## SERVICE BULLETIN SB271107

### ICON CONTAINER GROMMET INSPECTION Issue Date : November 27. 2007

Status : Precautionary

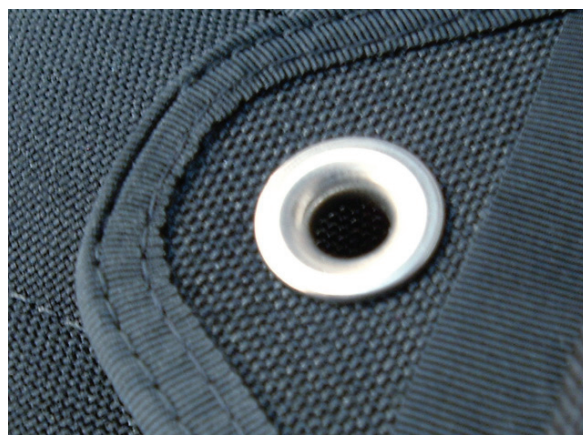
The Damage can be seen on the inside of the Grommet where the Closing Tool has scratched the Inside Surface of the Grommet. The seating of the Grommet needs to be inspected to ensure correct and flush seating of the Grommet.

1. Damaged Grommet  
see damage on inner ring of grommet

1. Undamaged Grommet

This could well be an isolated incident, but as a matter of precaution Aerodyne is recommending all Grommets on the ICONs listed in the Identification paragraph above be Inspected.
